SERVICE LETTER

No. 779

Piper Aircraft Corporation

Subject: Heater Fuel Pressure Relief Valve Inspection.

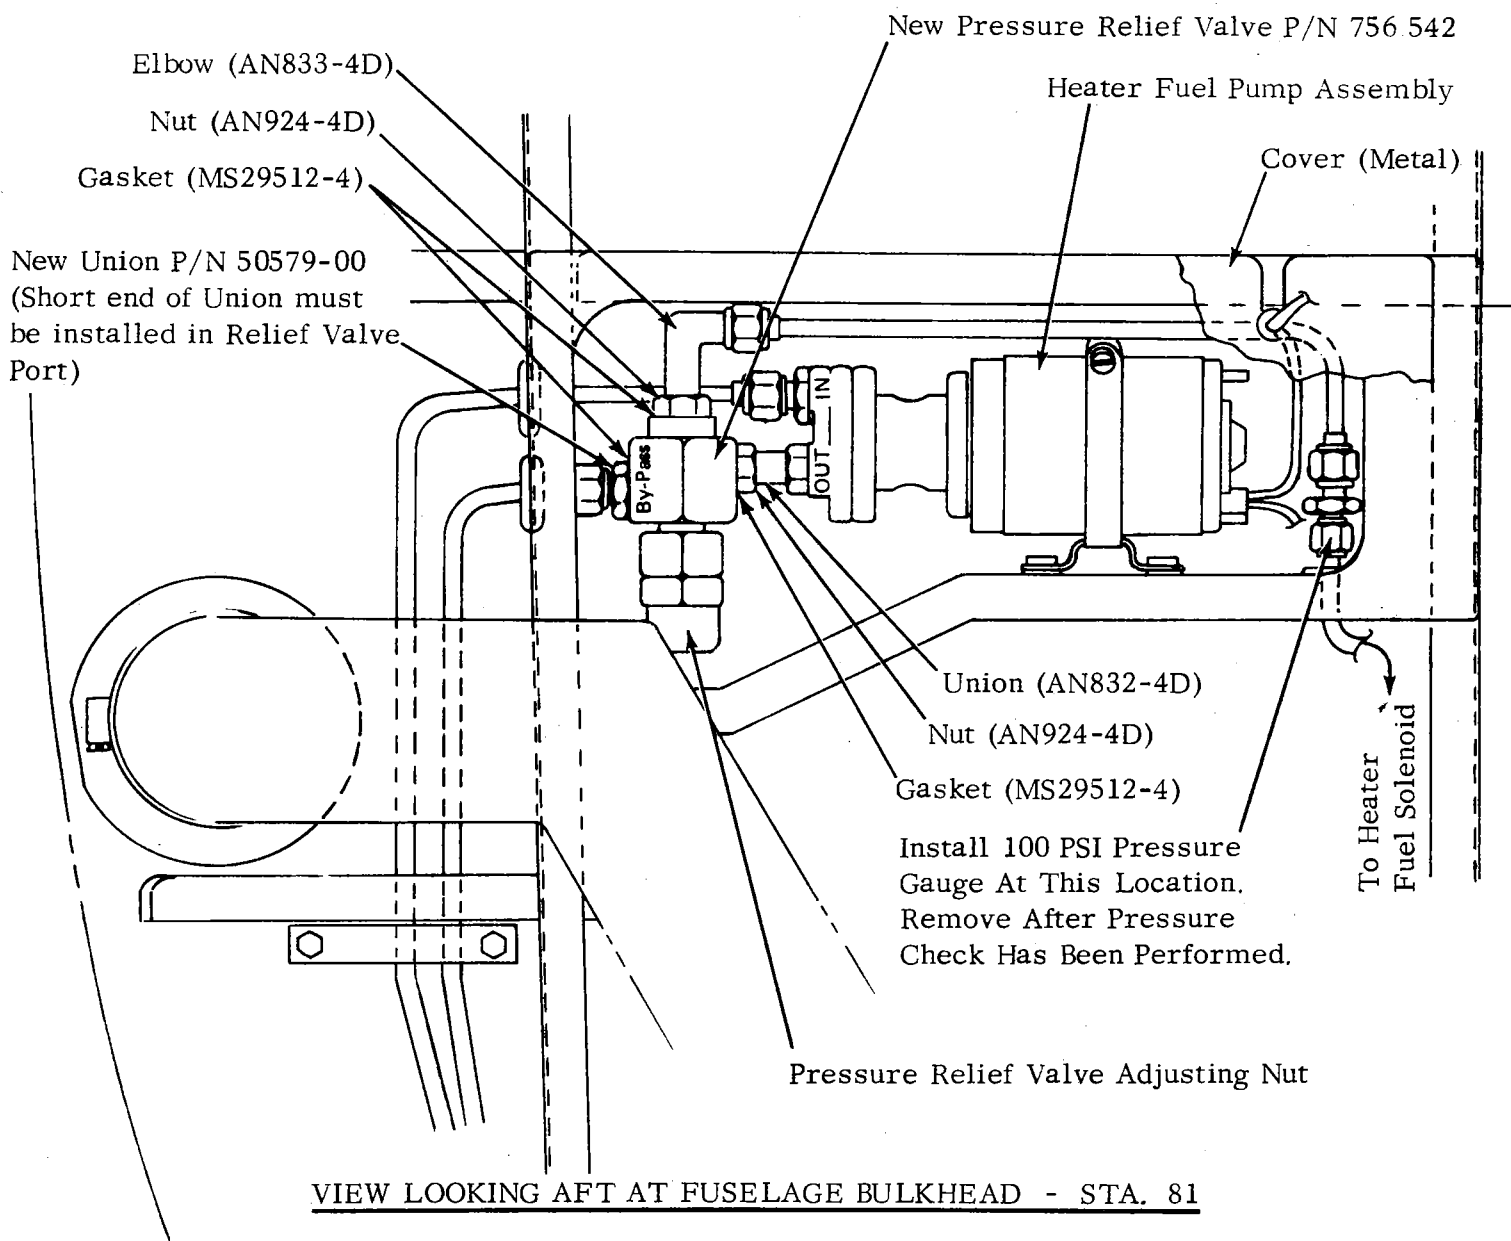
1. Gain access to heater fuel pump and pressure relief valve by removing access panel from right side of fuselage nose section.
2. Remove metal cover from bulkhead to expose pump and valve.

3. Disconnect fuel lines attached to pump and valve.
4. Remove pressure relief valve from fuel pump and disassemble fittings from valve.
NOTE: Discard nipple installed in By-Pass port of valve, and retain balance of fittings for reassembly on new valve.

5. Install short (flat) end of new union, P/N 50579-00, into By-Pass port of new pressure relief valve, P/N 756 542, using existing MS29512-4 gasket.
6. Install balance of existing fittings to new valve and assemble to pump.

7. Connect fuel lines to valve and pump, and tighten.
8. Install 100 psi pressure gauge into line from pressure relief valve to heater fuel solenoid.
9. With an engine fuel boost pump ON and with heater in operation, adjust heater fuel pressure to 100 psi with the pressure relief valve adjusting nut.

10. After adjustment, remove pressure gauge and reconnect heater line.
11. Reinstall metal cover and fuselage access panel.
12. Make proper logbook entry of valve and nipple replacement.
